DRAINAGE CERTIFICATION W/SURVEY WORK BY OTHERS

Car Crafters
Automotive Repair Garage
5404 Edith Blvd. NE
Albuquerque, New Mexico 87107

AS-BUILT

Project Number
Drawn By T.D.S.
Checked E.J.L.
Issue Date 12/22/2011
GRADING AND DRAINAGE PLAN

C102A

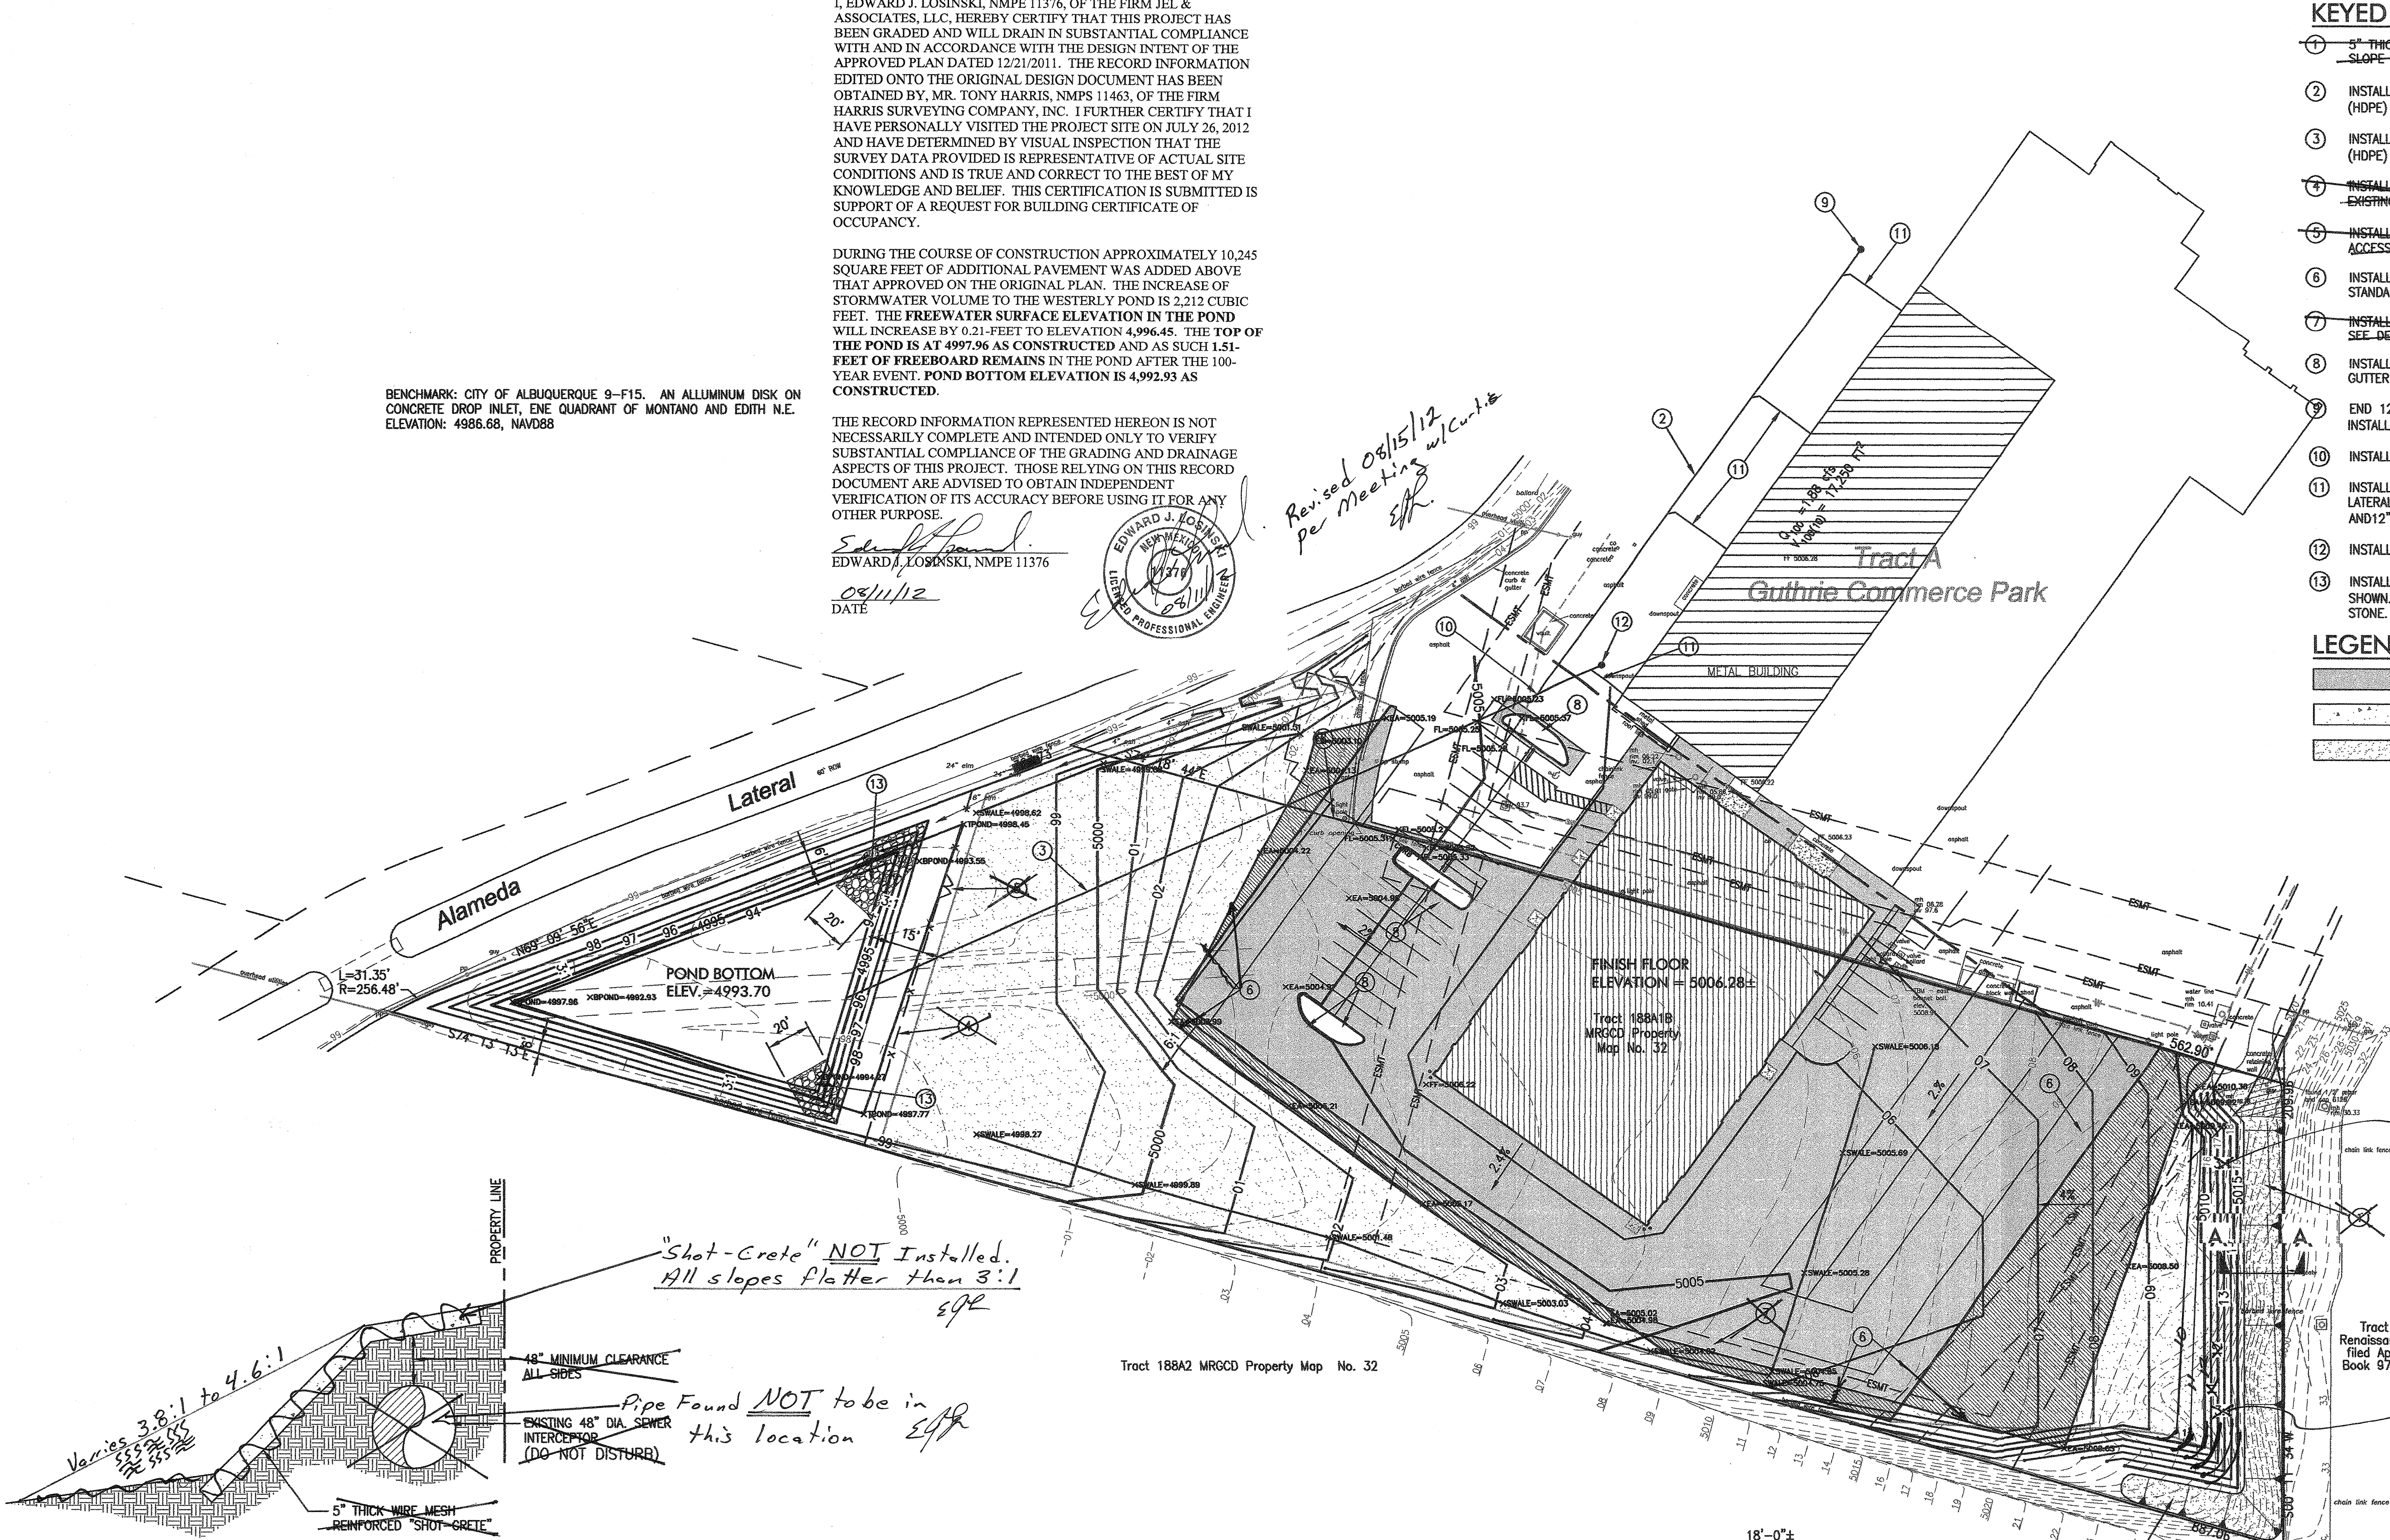
DURING THE COURSE OF CONSTRUCTION APPROXIMATELY 10,245 SQUARE FEET OF ADDITIONAL PAVEMENT WAS ADDED ABOVE THAT APPROVED ON THE ORIGINAL PLAN. THE INCREASE OF STORMWATER VOLUME TO THE WESTERLY POND IS 2,212 CUBIC FEET. THE FREEWATER SURFACE ELEVATION IN THE POND WILL INCREASE BY 0.21 FEET TO ELEVATION 4,996.45. THE TOP OF THE POND IS AT 4997.96 AS CONSTRUCTED AND AS SUCH 1.51 FEET OF FREEBOARD REMAINS IN THE POND AFTER THE 100-YEAR EVENT. POND BOTTOM ELEVATION IS 4,992.93 AS CONSTRUCTED.

- 5" THICK "SHOT-CRETE" WITH WIRE-MESH REINFORCING. *Not Built EJR*
- INSTALL 250 L.F. OF 12" DIA. HIGH DENSITY POLYETHYLENE (HDPE) STORM DRAIN. MINIMUM SLOPE = 0.5%.

- INSTALL 374 L.F. OF 12" DIA. HIGH DENSITY POLYETHYLENE (HDPE) STORM DRAIN. MINIMUM SLOPE = 0.5%.
- INSTALL APPROXIMATELY 170 L.F. OF FENCING TO MATCH EXISTING PERIMETER FENCING. *Not Built EJR*

- INSTALL 12" WIDE (DOUBLE 6") GATES FOR MAINTENANCE ACCESS TO PONDS. MATCH EXISTING PERIMETER FENCING. *Not Built EJR*
- INSTALL HEADER CURB FLUSH WITH ASPHALT PER COA STANDARD DETAIL 2415.

- INSTALL CONCRETE PAVING SECTION FOR TRASH DUMPSTER. SEE DETAIL THIS SHEET. *Not Built. Trash Dumpster Remains at pre-development location EJR*
- INSTALL CURB AND GUTTER TO MATCH EXISTING CURB AND GUTTER WITHIN THE CAR CRAFTERS FACILITY.
